**City of Carpinteria**  
**Architectural Review Board Agenda**  
**Thursday, August 27, 2026**  
**Council Chamber, 5775 Carpinteria Avenue,**  
**Carpinteria, CA 93013**

1. Project: Zuvella Lot Split & New Residence Concept, Project 26-2399-CON  
Address: 5533 Callejon Drive  
Applicant: Kyle Zuvella, property owner  
Planner: Syndi Souter

**CITY OF CARPINTERIA  
ARCHITECTURAL REVIEW BOARD  
Meeting of August 27, 2026**

**Project:** 26-2399-CON  
**Address:** 5533 Callejon Drive  
**APN:** 003-340-003  
**Zoning:** Single Family Residential (6-R-1)  
**Applicant:** Kyle Zuvella

5533 CALLEJON AVE, CARPINTERIA, CA 93013  
PROPOSED FLOOR PLAN - MAIN LEVEL 05/13/26

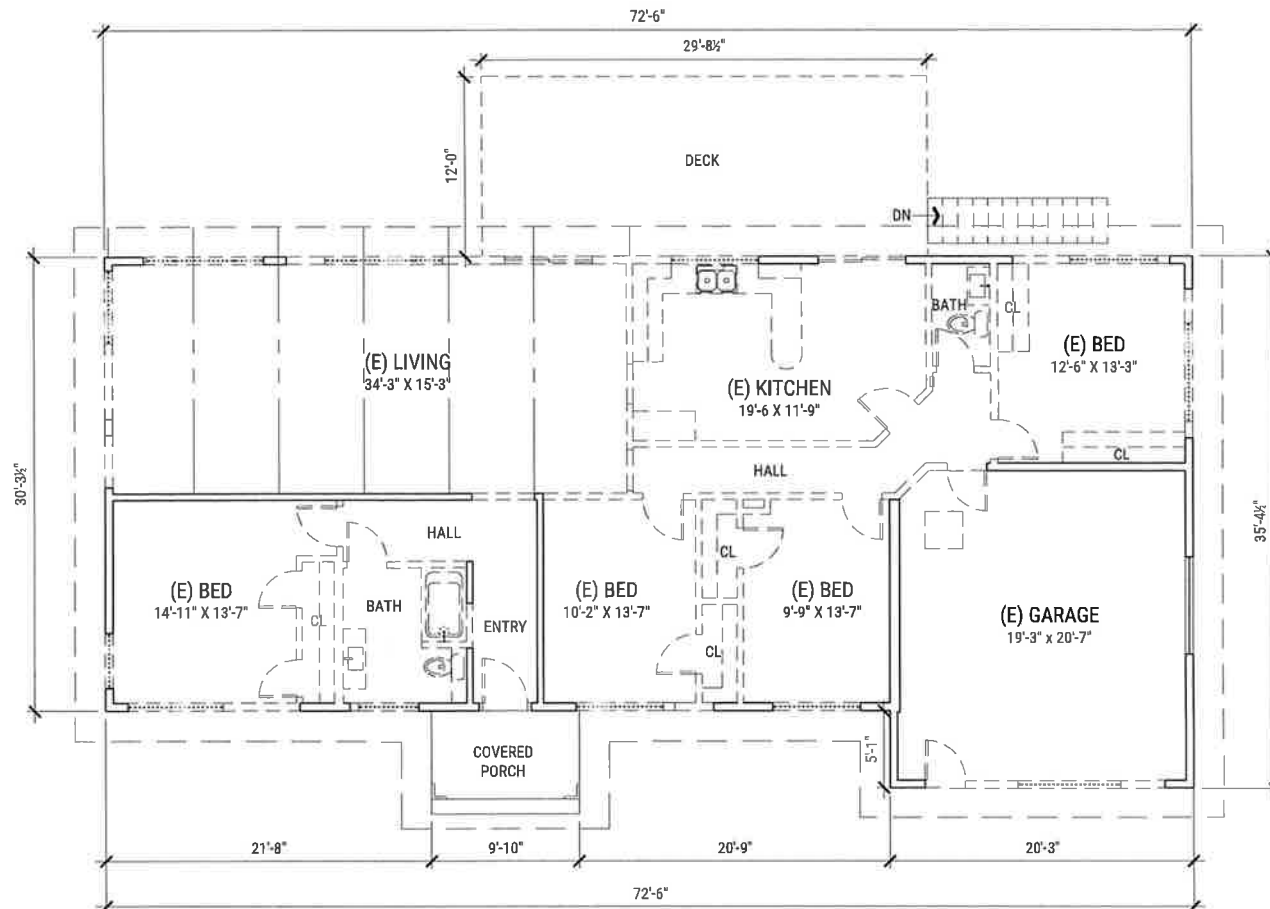
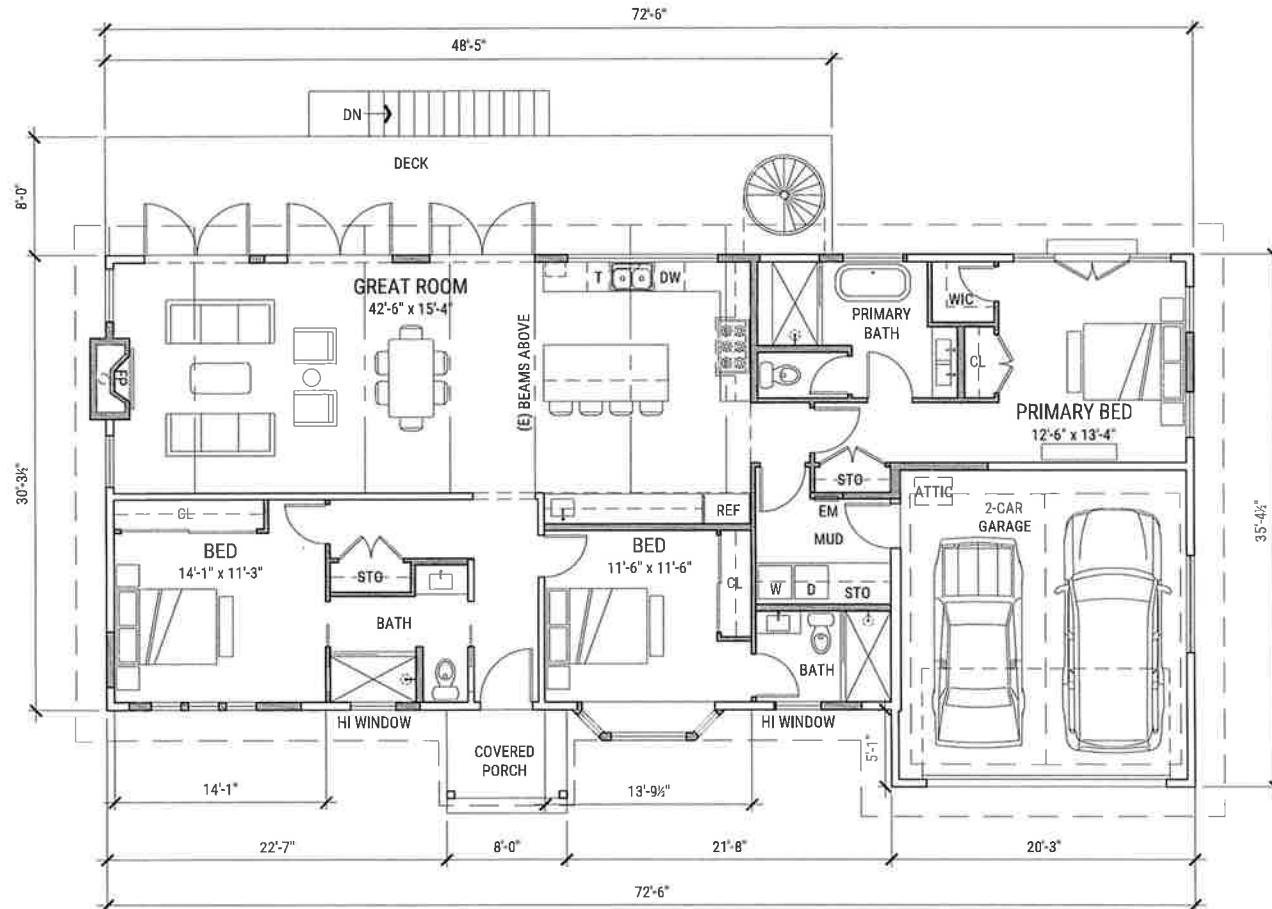
The concept proposal includes plans for a comprehensive remodel to the interior and exterior of the existing two-story single-family residence. The main floor of the residence lies at street level, and the structure presents as a single-story home with a maximum height of 13-feet from the public street view. The second level of the residence is a basement nestled into the hillside that daylights at grade in the back yard. The contemplated exterior alterations would add Tudor/Storybook Cottage elements to the residence with a new high-pitched open gable roof over the front entry, a white brick or stone veneer on the body, steel windows, a synthetic cedar shake roof, copper gutters, and natural wood doors. At this conceptual level, new landscaping and hardscape plans have not been developed.

**The Board should comment on the architectural style of the concepted exterior alterations.**

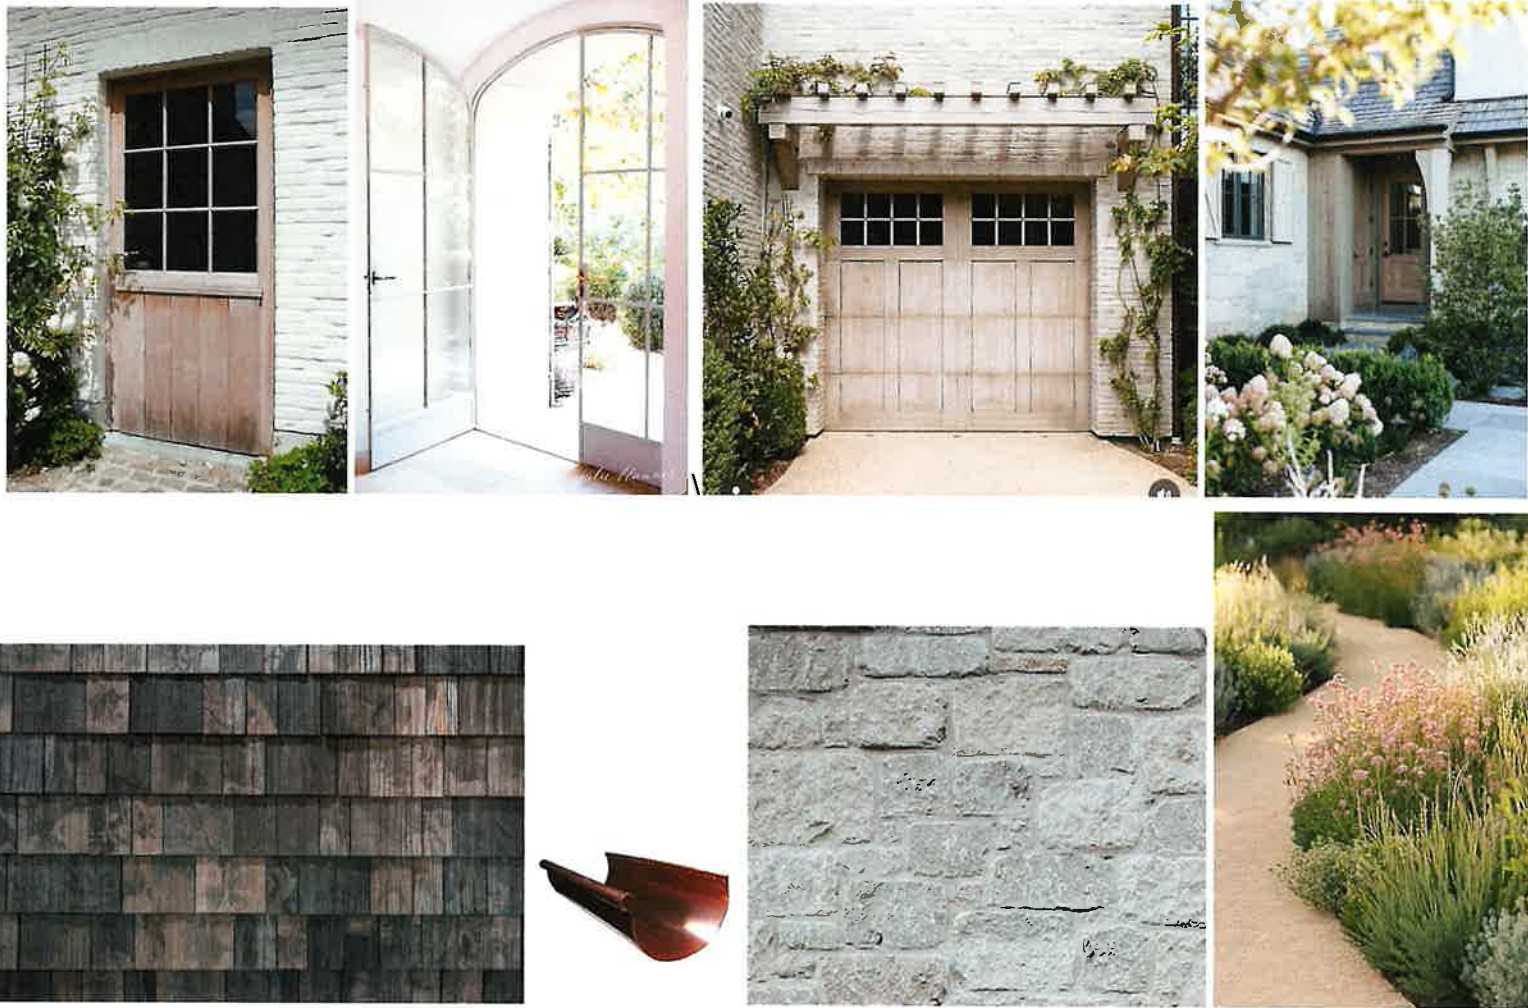
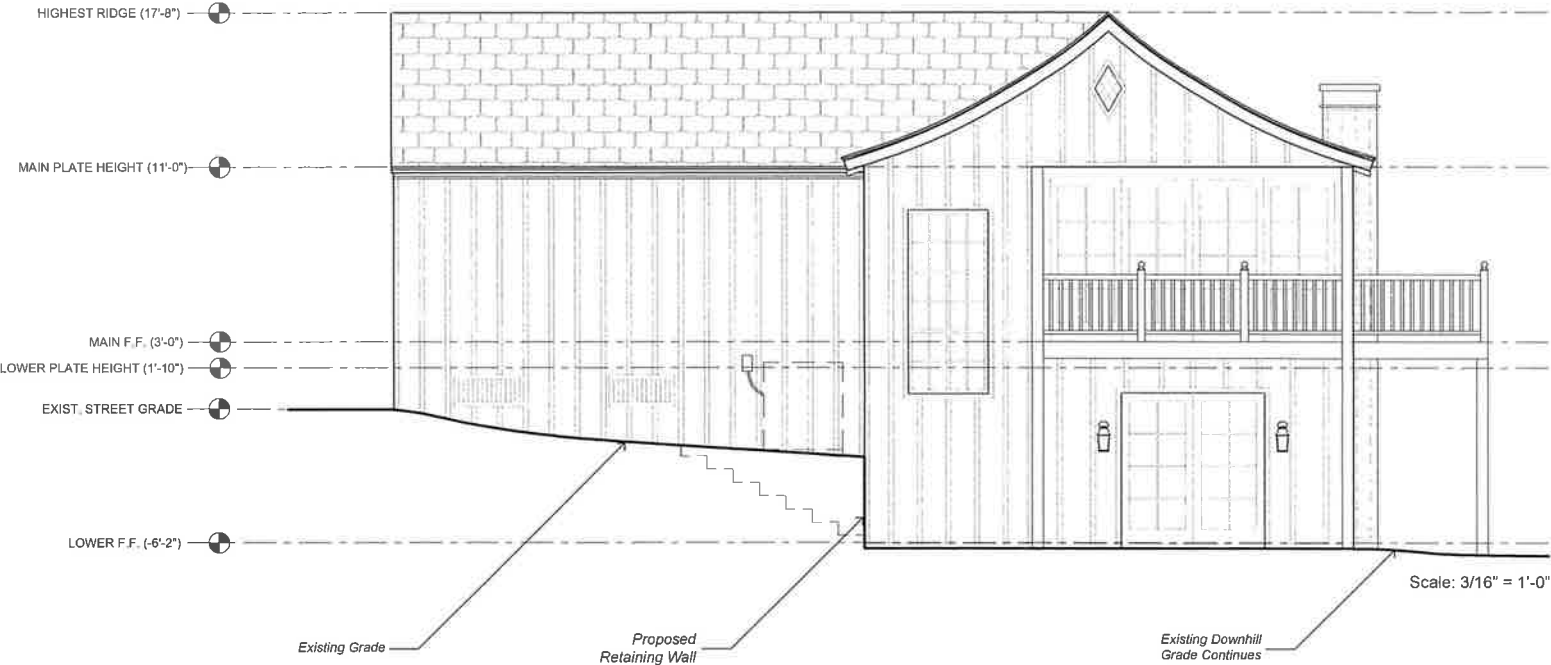
The architecture of the conceptual residence would be Tudor/Storybook Cottage style to be similar to the renovations proposed for the existing residence. The front and side elevations would include open-gable rolled roofs. The exterior would be dark brown vertical board-and-baton siding with

brick accents on the front planters and fireplace. The roof would be synthetic cedar shake with copper gutters. Wooden doors and windows with multiple muntins and lites are proposed throughout. The front elevation would include an arched front door and a bay window with a copper roof. Native landscaping is referenced on the concept imagery, but a concept landscaping and hardscape plan has not yet been provided.

**The Board should comment on the architectural style, height, and massing of the concepted residence.**

As mentioned previously, the contemplated architectural style would be similar to the existing ranch and cottage styles found in the neighborhood. However, the two-story mass of the conceived new residence would be a departure from the typical development pattern in the vicinity. Also, two-story development, while allowed in this neighborhood by the City, continues to be controversial. On recent past projects, significant effort has been put into trying to minimize the visual prominence of new two-story construction through careful placement, massing, and use of split-level plans and topography, in an effort to preserve the largely single-story character of the neighborhood. The current proposal locates the second-floor mass below the main level, ostensibly to preserve views over other parts of the property, however the massing and height on the east and rear sides result in a visually very prominent solid two-story mass.

The conceptual residence would be set back 20-feet from the street, which follows the pattern of other residences along the street. However, although the second story is partly nestled into the hillside below the main level, the upper and lower levels are stacked rather than stepped back. Other two-story homes elsewhere in the Concha Loma Neighborhood have the second-story set back towards the center or rear of the residence, and often more “nested” into the structure. The design of the conceptual residence would cause a looming presence on the east and rear/south elevations, and could impact privacy with adjacent neighbors.

As mentioned above, the massing and height of the conceptual residence would be out of character with most of the other homes in the immediate area. The proposal could be massaged to have split levels to better integrate into the topography to become more compatible with the other existing homes in the neighborhood. The Tudor/Storybook Cottage architectural style chosen for both residences appears to be compatible with the mix of styles in the neighborhood. Should the proposal move forward with a formal submittal, the applicant should consider removing the brick wall and extensive asphalt paving along the street frontage and replacing it with landscaping and pathways to the entrances. The existing residence would be set back 17.17-feet and 10-feet from the sides, and 61-feet from the rear property lines of the proposed 12,097 square-foot lot, so it would comply with DG 10.

The conceptual residence has several large windows and French doors, predominantly located on the side and rear elevations. As discussed above, the window sills could be raised to minimize views into adjoining lots and reduce privacy impacts with adjacent neighbors. Additionally, the conceptual residence has a rear deck that would overlook the backyards of the existing residence and the neighbors to the south. Privacy impacts from the deck could be reduced by stepping the first level back and/or using a solid wall rather than railings to enclose the deck.
